Technical product information

Transaction No.: 2033480/2

Gear range selector inoperative

Release date: 11-Sep-2013

Figure 1

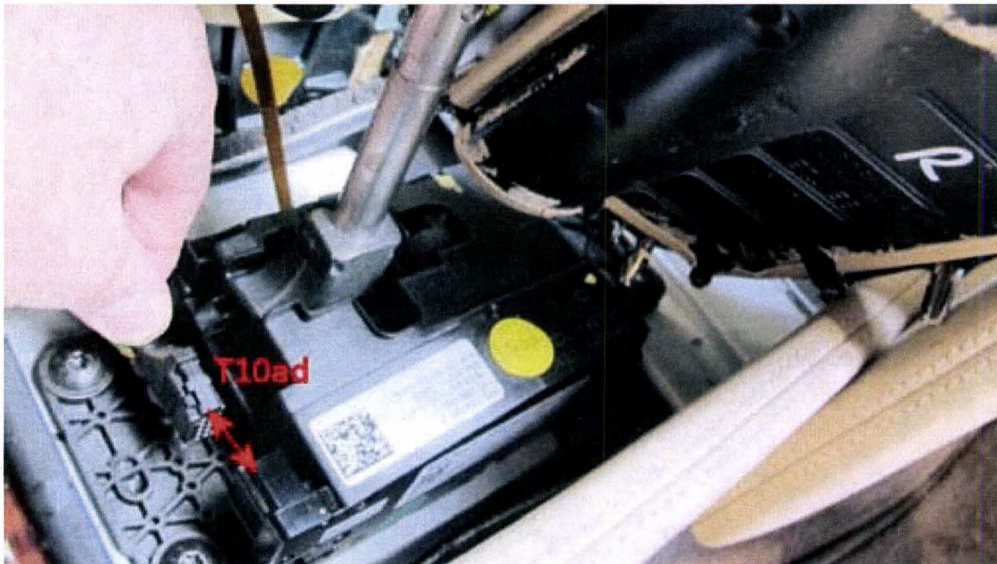
To disconnect/reconnect the gear selector electronics disconnect the 10 way connector (connector T10ad in current flow diagrams) at the gear selector assembly (see Figure 1)

5. On return to the workshop remove the suspect gear selector electronics control unit (part number 3Y0927731A) and replace with the later control unit (part number 3Y0927731B). Refer to workshop manual Rep. Gp.37 Gear selector control unit (J98) To remove and fit

Figure 2

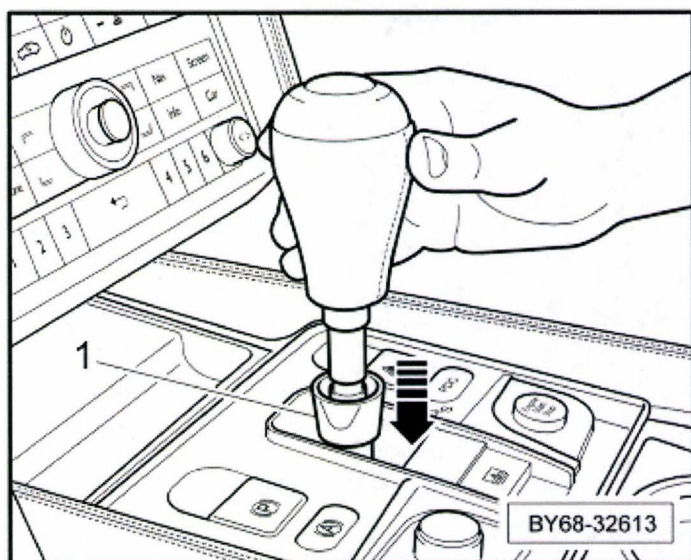
1. Slide the collar -1- downwards then pull off the gear selector knob

Figure 3

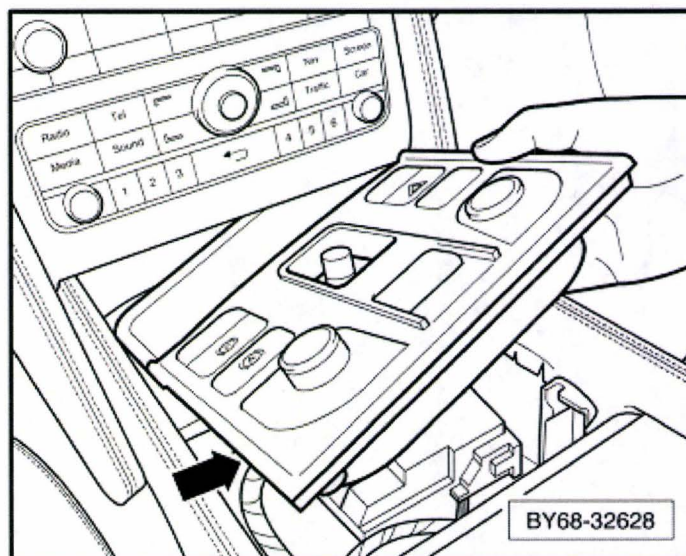
2. Pull the switch pack upwards from the rear edge
3. Disconnect the harness connector arrowed – from the rear of the switch pack  
**Note:** as long as the ribbon cable is not strained it can remain connected for this operation
4. Disconnect and reconnect connector T10ad (see Figure 1)  
 Communication should now be possible - Clear the event memory entries - Test the gear selection function and re-assemble
